23 INDIVIDUALS

Palmdale - Burbank - RECORD #4026 DETAIL

Figure 1 –Aerial photograph showing wildlife movement opportunities, looking north from Agua Dulce Canyon Road, through the Linkage Design, across the SR 14 freeway corridor with UC Davis Wildlife-Vehicle Conflict Hotspots identified.

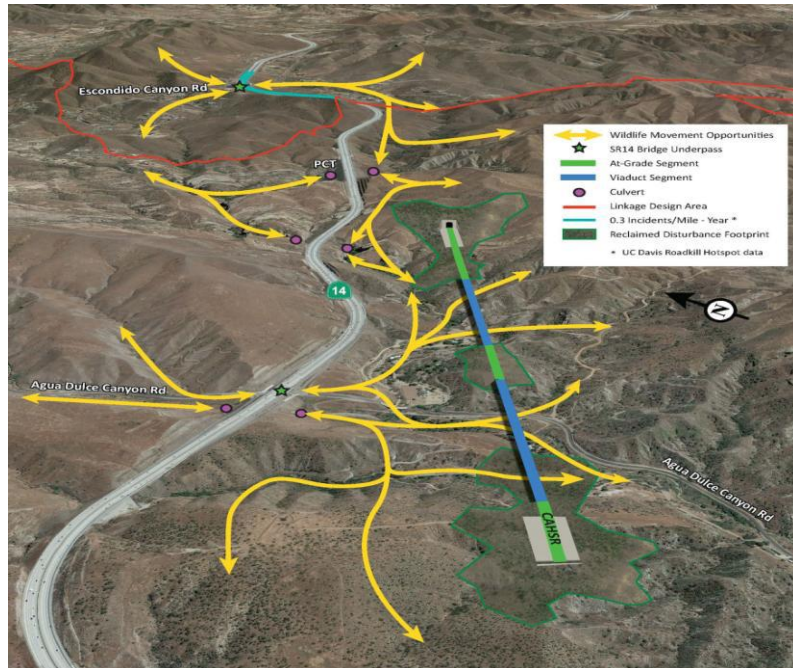
Wildlife connectivity is one of my main concerns. Either alternative needs to put sufficient crossings, making a system not a few token crossings. Studies showing the best sites, corridors that can be used and fencing for track avoidance and guiding must be designed.

Figure 3 –UC Davis' Real-time Deer Incidents &Wildlife-Vehicle Conflict (WVC) Hotspots map, September 16, 2023

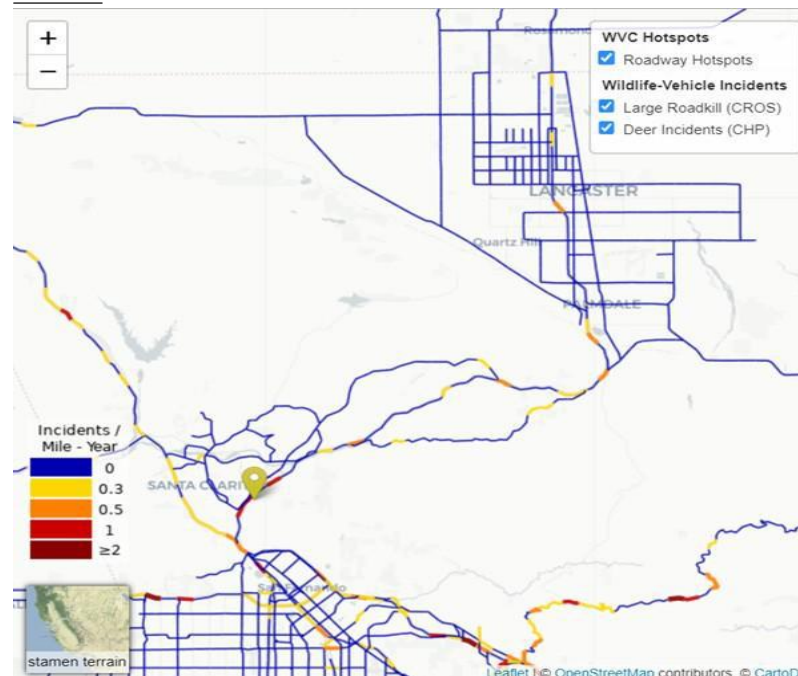
year (attached Figure 3). The hotspot map Areas identified as high wildlife use areas align with permeable sections of the SR14 and SR14A Alternatives also illustrated on attached Figures 1 and 2. Those areas that are not permeable were reviewed for crossing opportunities where wildlife could move across the existing landscape. Two additional crossings were added to address crossing interval spacing in an area that had a long at-grade segment to provide additional wildlife crossing opportunities near Una Lake (SR14A and E2A Build Alternatives) and adjacent to the California Aqueduct (SR14A, E1, E1A, E2, and E2A Build Alternatives) (see p. 3.7-197 of Draft EIR/EIS). The WCA determined the effect to wildlife movement was less than significant because of the extensive network of permeable tunnels and viaducts that align with the existing SR 14 freeway bridge undercrossings and wildlife roadkill hotspots, maintaining wildlife movement. Refer to Graphs 6-1 through 6-15 of the WCA that illustrate the relative comparison of existing and project permeability for each of the focal species.

Sketched block diagram shows (light green) high-speed rail line with red faults beneath the "blind thrust" zone of the San Gabriel Mountains. Red arrows indicate general compressive (principal) stress. The left shallower hypocenter is San Fernando; the right deeper epicenter is Northridge.

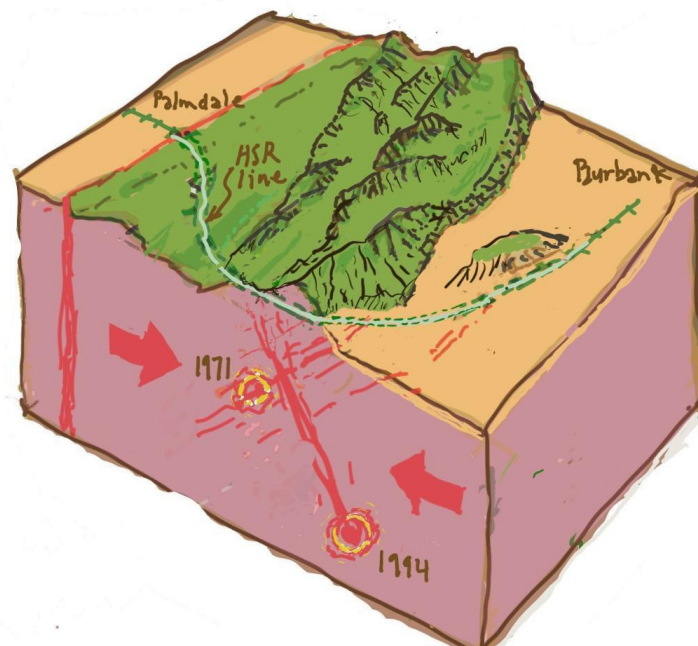
This report examines the adequacy of understanding and documentation (DEIR) of the environmental impact of construction of a 38-mile section of the California High-Speed Rail project (CHSR) by the California High Speed Rail Authority (CHSRA) which is meant to connect northern and southern California. Some parts of the project in California's Central Valley are approved and under construction at present (November 2022). The feasibility of building the reach from Palmdale to Burbank, tunneling at depths of up to 2000 feet beneath the San Gabriel Mountains, is one of the most problematic of the entire system because of the extreme physical geography of the San Gabriel Mountains which it traverses. The DEIR for this reach is currently under consideration with regulatory decisions on the DEIR due for late 2022. This report sets forth results of our review of the geotechnical elements of the DEIR and raises questions about this specific Palmdale-Burbank section which we ask the reviewers to consider.¹

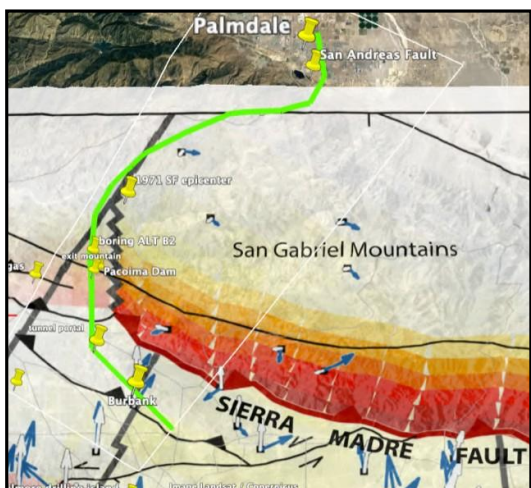
The geology section of the DEIR considers only three faults which it considers to be significant potential for track displacement: the San Andreas, San Gabriel, and various surface faults in the San Fernando Valley. However, the hydrology section of the DEIR report (Section 3.8) indicates there are other known and unknown faults on the alignment that could affect groundwater flow. Our view is that these unknown faults, to be discovered in a more extensive geotechnical investigation order during construction, will also need to be considered in regard to the question of track alignment and derailling.

However, it is likely that not all faults in the ANF have been mapped because of limited surface evidence and the inherent limitations of surface geologic investigations. Additional geological investigation would occur before final design and construction.

As stated by the commenter and shown in the Table 3.9-4 in Section 3.9 of the Draft EIR/EIS, all six Build Alternatives will cross the San Andreas Fault (Mojave Section) at grade near Lake Palmdale. Trackway profiles, stations, and ancillary features associated with all six Build Alternatives could experience violent seismic ground shaking, particularly near the San Andreas Fault (see Figure 3.9-19 in Section 3.9 of the Draft EIR/EIS). The anticipated design ground displacements would not "instantly and completely destroy the rail," although for the Maximum Considered Earthquake (MCE) event, extensive repairs or complete replacement of some components of the system may be required before train operation may resume. As established by GEO-IAMF#7, potentially hazardous faults crossed by the HSR Build Alternatives would be evaluated by conducting field investigations to establish updated estimates of levels of ground motion prior to construction and during final design. Final design would be further
